SUNDRY NOTICES AND REPORTS ON WELLS

☐ Oil Well ☒ Gas Well ☐ Other8. Well Name and No.
ARTEMIS FEDERAL COM 1

Well Procedure

Artemis Fed Com #1

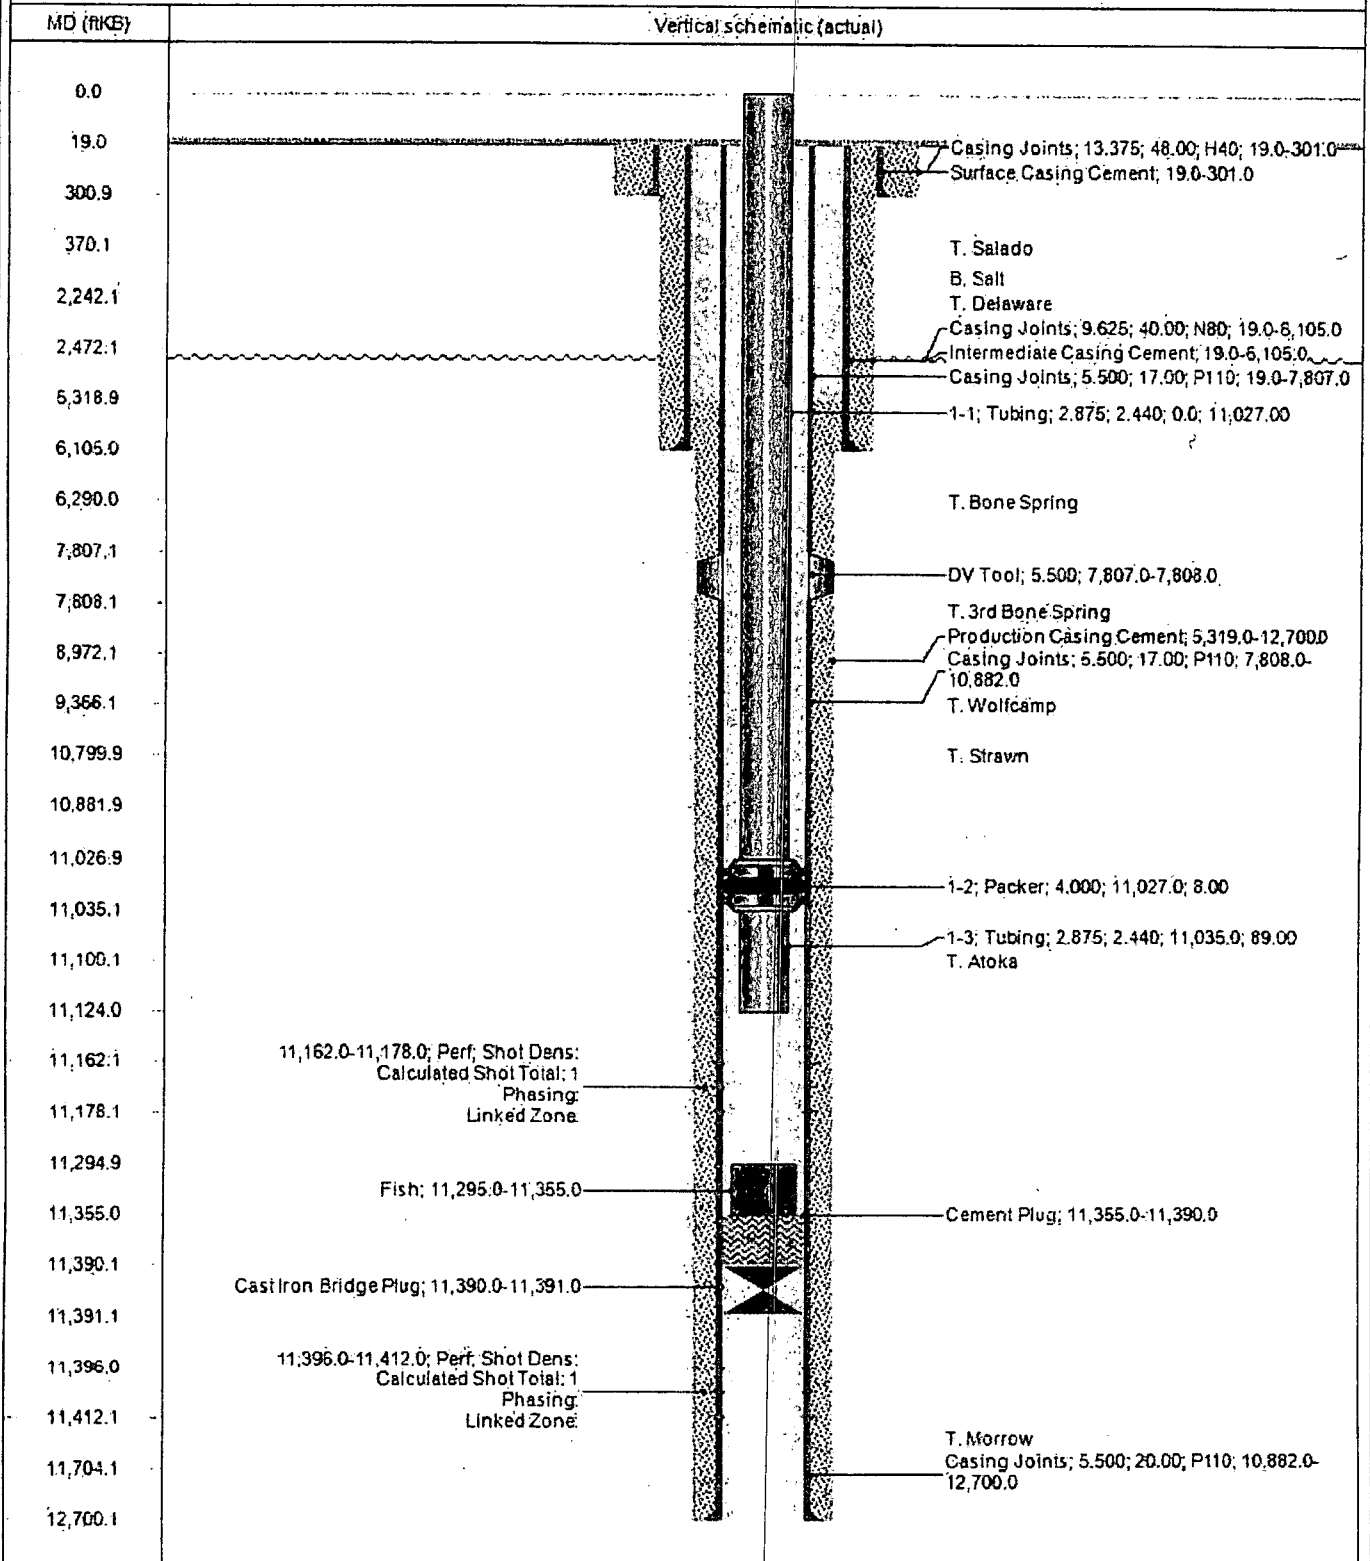
- 11, 112
1. CIBP @ 11000' w/35'. Must Use Bailer. Leak Test CIBP
2. 30sx @ 9446' - 9516' 4507' - 4307' H
3. 30sx @ 7858' - 7758' 7858' - 7678' class H TAG
4. 50sx @ 6155' - 6055' P.S. 100 sx 6155' - 5862' TAG C
5. 40sx @ 2202' - 2402' P.S. 80 sx 2580' - 2207' TAG C
6. 50sx @ 655' - 555' P.S. Tag
7. 155sx 471' - Surf. P.S. & Verify. Install DHM.
404'

1. Prep location. Contact New Mexico regulatory
2. MIRM NDWH NU BOP POOH w/prod equipment
3. Run GR. Set CIBP @ ^{11, 11.2} 11,000' w/35'. Must Use Bailer. Leak Test CIBP
4. TIH to CIBP. Circ w/P&A mud.
5. Spot 30 sx @ ~~9416~~ 9507' - 9307' class H (Wolfcamp @ 9457')
6. Spot 30 sx @ ~~7858~~ 7858' - 7678' class H TAG (DV Tool @ 7807')
7. P&S ¹⁰⁰ ~~50~~ sx @ ~~6155-6055~~ 6155' - 5862' TAG CLASS C (Shoe @ 6105' & Bone Sp. @ 5970')
8. P&S ⁸⁰ ~~40~~ sx @ ~~2292-2192~~ 2530' - 2207' TAG CLASS C (Base. Salt @ 2282' &
9. P&S ¹⁵⁵ ~~120~~ sx @ ^{404'} ~~351~~ surf & verify. Top of Salt @ 354' class C (Delaware @ 2530')
10. ND BOP. Remove WH. Install DHM.
11. RR. RDMU.

GC 2/24/20
Accepted for record - NMOCAPPROVAL SUBJECT TO
GENERAL REQUIREMENTS AND
SPECIAL STIPULATIONS
ATTACHED
